**EXHIBIT L**

**APPEAL APPLICATION AND ATTACHMENTS**

**Case Number:** ADM-2023-4274-DB-VHCA-ED1

**Project Address:** 8217 N. Winnetka Avenue

SITE PLAN | 3/32" = 1'-0" | 1

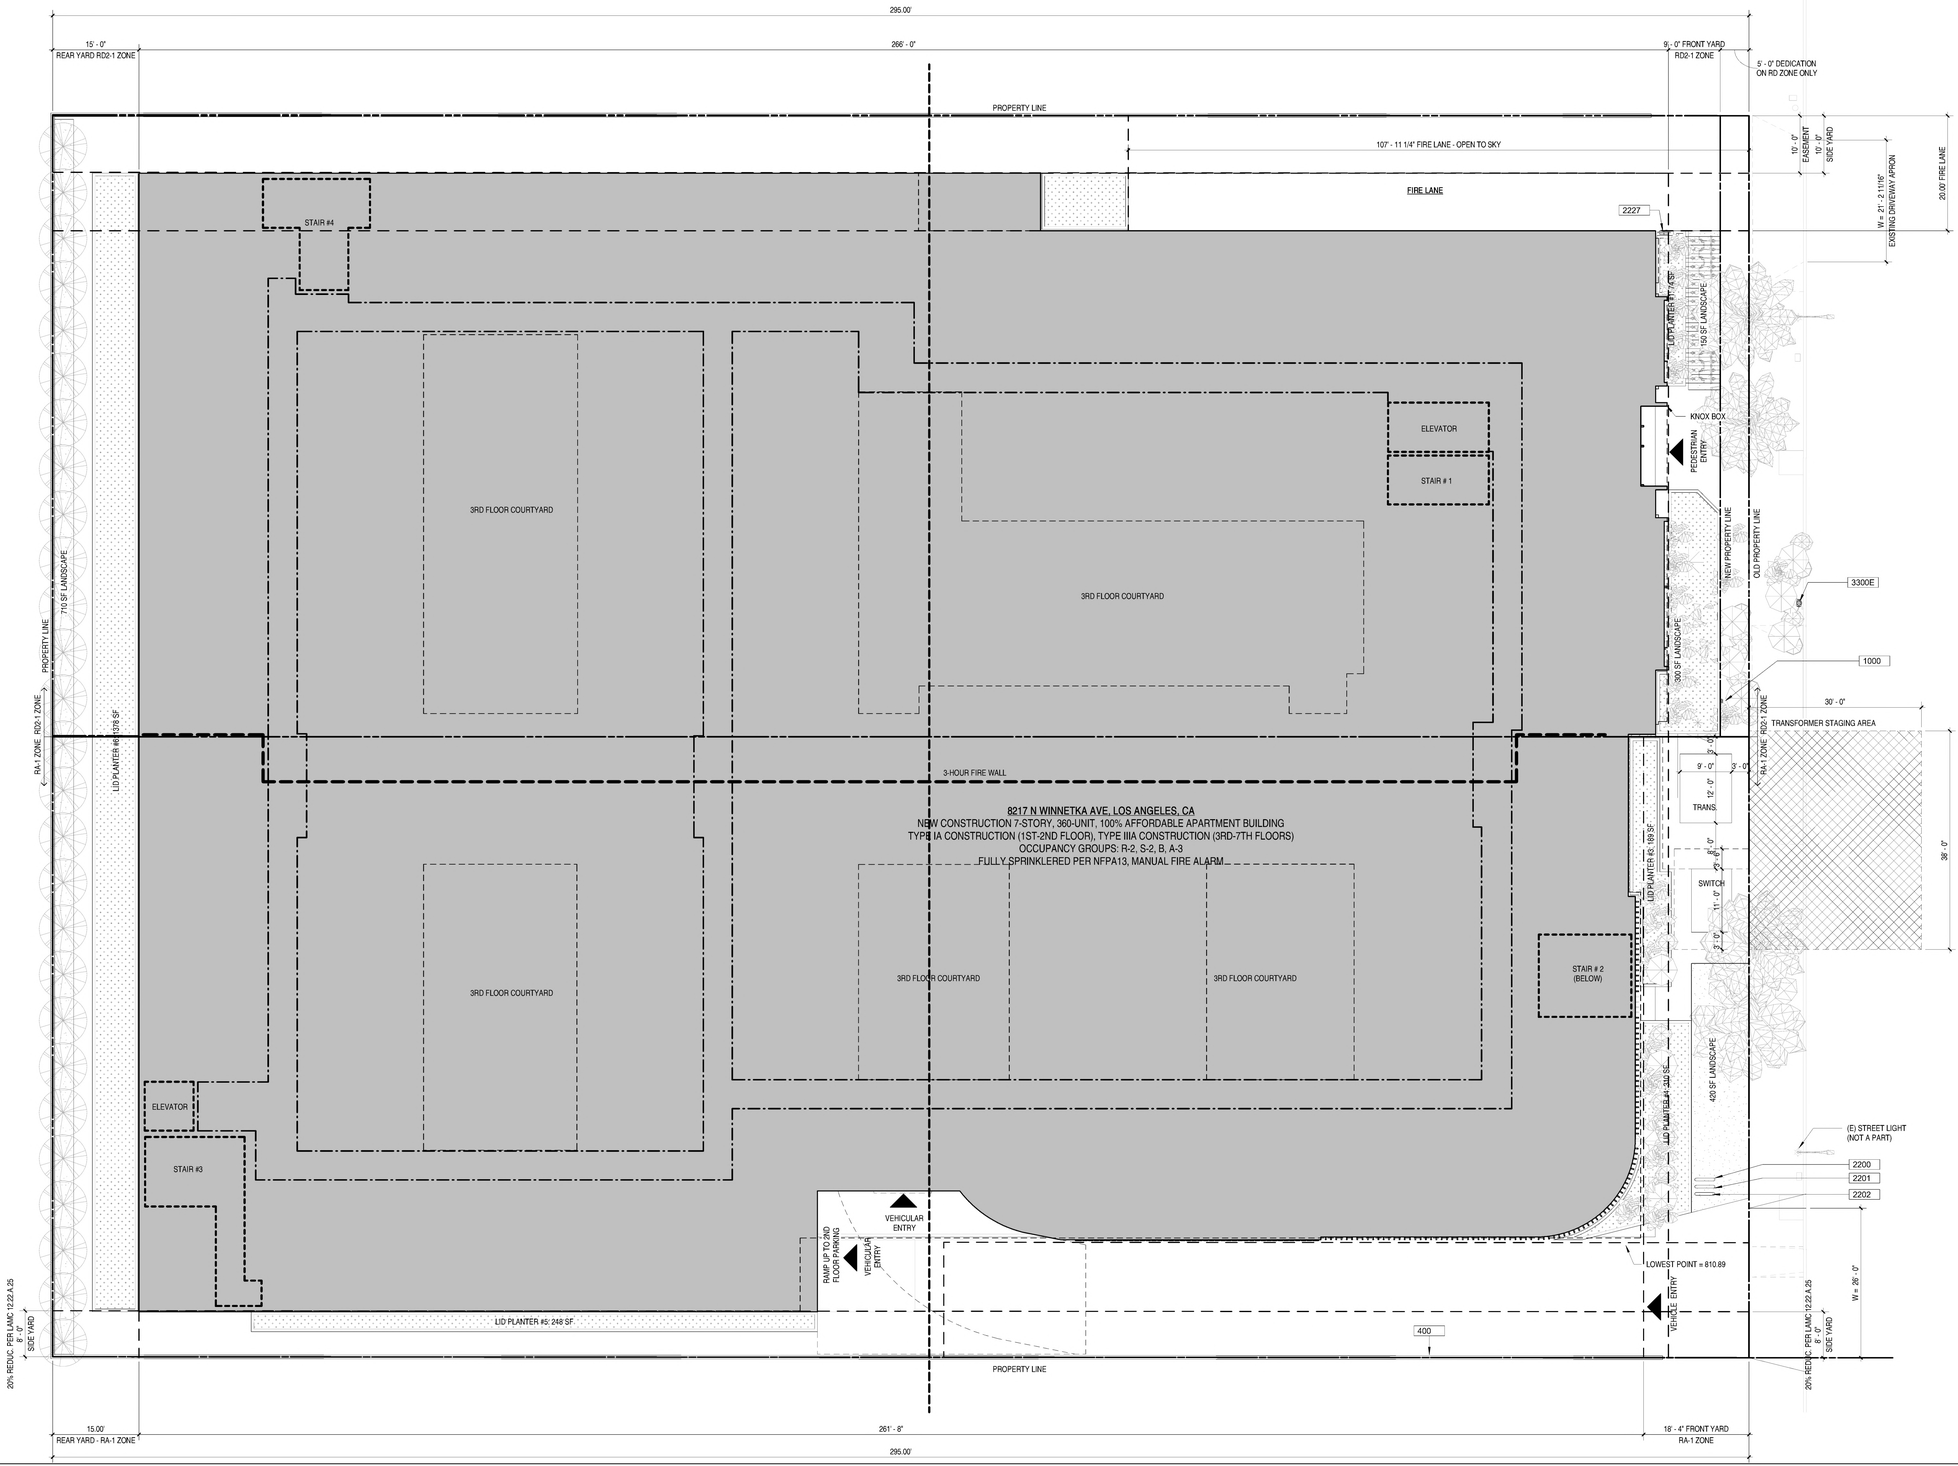
| No | Item for Correction | Correction Required | Date Corrected | Initials of Approval |
|---|---|---|---|---|
| 6 | Site/Plot Plan | A project information sheet (Sheet G001 and Site Plan (Sheet A000) were provided but need to be amplified, corrected, clarified, and supplemented as follows:<br>• Both Sheets G001 and A000 cannot be read at the reduced size and must be corrected. An illegible or inadequate Site Plan cannot be accepted. When reducing full-sized plans, font sizes and dimensions shall be made large enough so they can be read at the reduced size.<br>• General Plan Land Use on p. G001 must be corrected from "Low Medium Residential" to "Low Medium II Residential"<br>• FAR and RFAR calculations need to be confirmed by LADBS as part of the PZA review and approval.<br>• You must disclose entitlements requested on the plans, and entitlements requested are not shown on Sheet G001.<br>• Sheets G001, A000, and other application materials are not consistent regarding the rear yard reduction requested. Plan Sheet G001 discloses a 40% off-menu reduction in the RA Zone. However, Attachment A to Department of City Planning Application discloses a request for a waiver of development standard for a reduction in the RA Zoned rear yard. The AHRF (Sections 4 and 10B) do not disclose a rear yard reduction in the RA Zone. Sheet A000 shows a 15 foot rear yard. All materials must be corrected for consistency.<br>• The provided density disclosed on Sheet G001 is inconsistent with other application materials and needs to be corrected for consistency. Sheet G001 shows 360 units (291 low income + 72 moderate). Attachment A to the Department of City Planning Application shows 360 units (287 low income + 72 moderate + 1 manager/unrestricted). The AHRF discloses 365 units (291 low income + 73 moderate income + 1 manager's unit/market rate). All plans and other | | |

| No | Item for Correction | Correction Required | Date Corrected | Initials of Approval |
|---|---|---|---|---|
| | | application materials need to be corrected for consistency.<br>• Sheet G001 shows the project is providing 261 parking stalls but this is inconsistent with other application materials and needs to be corrected. The Department of City Planning Application, Section 2 shows the project is providing 269 parking stalls but the AHRF shows the project is providing 272 parking stalls. You must make these plans and application forms consistent.<br>• Incentives Requested on Sheet G001 is not consistent with other application materials and must be corrected for consistency. Sheet G001 discloses a total of four incentives as follows: averaging across the RD2 and RA Zones (on-menu); 20% south side yard reduction (on-menu); 30% reduction of bicycle parking (off-menu); 40% front yard reduction in RD2 Zone (off-menu). This is inconsistent with the Department of City Planning Application Attachment A which also discloses incentives for a front yard reduction in the RA Zone. This is also inconsistent with the AHRF which discloses requests for front yard reduction in the RA Zone as an off-menu incentive. The disclosure of requested incentives on Sheet G001 is also inconsistent with Preliminary Case No. PAR-2023-1802-VHCA-ED1 which requests "…four incentives for averaging, two yard reductions and open space reduction…" All materials must be corrected for consistency.<br>• Sheet G001 discloses the 7 waivers of development standards which is inconsistent with other application materials and must be corrected for consistency. Sheet G001 discloses the following requested waivers: front yard/building line reduction in the RA Zone; rear yard reduction in the RA Zone; total height of 80 feet 3 inches; reduction in open space; increase in FAR/RFAR; 20 24-inch box trees; and 65% compact parking stalls. However, the Department of City Planning Application, Attachment A, requests the following 5 waivers: reduction of rear yard in the RA Zone; increase of height of 80 feet 3 | | |

| No | Item for Correction | Correction Required | Date Corrected | Initials of Approval |
|---|---|---|---|---|
| | | inches; increase in FAR/RFAR; reduction in open space; 65% compact parking. This is inconsistent with the AHRF which requests 3 waivers: increase in height to 79 feet; increase in FAR/RFAR; reduction in open space. Furthermore, this is inconsistent with Preliminary Case No. PAR-2023-1802-VHCA-ED1 which requests "…waivers of development standards for height and FAR/RFAR."<br>• Sheet G001 discloses 20 24-inch box trees but states that a total of 90 24-inch box trees will be required. Is the applicant requesting an incentive or waiver of landscaping requirements? If so, this must be disclosed and evaluated by Planning given the applicant's request for an on-menu incentive for reduced yard setbacks which requires increased landscaping.<br><br>See Plot_Plan_Instructions.pdf (lacity.org) | | |
